## Rio Grande Resources, Corp. Mt Taylor Mine 12/27/21

## Addendum to "Work Plan for Post-Mining Radiological Surveys of Permit Area and Impacted Lands" Mount Taylor Mine Cibola County, New Mexico

April 23, 2012 Soil Investigation

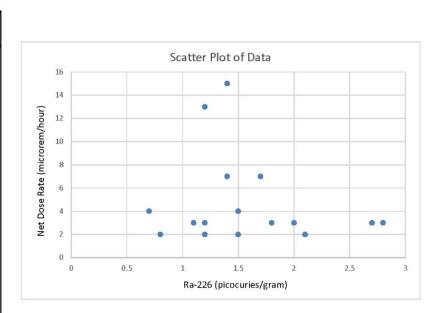
## 4) Data and Results of the Regression Analysis of the 2012 Study (response to Comment #10):

Slope =	-1.140
Y Intercept =	6.538
$R^2 =$	0.030

### **Regression test failed**

**Negative Correlation**
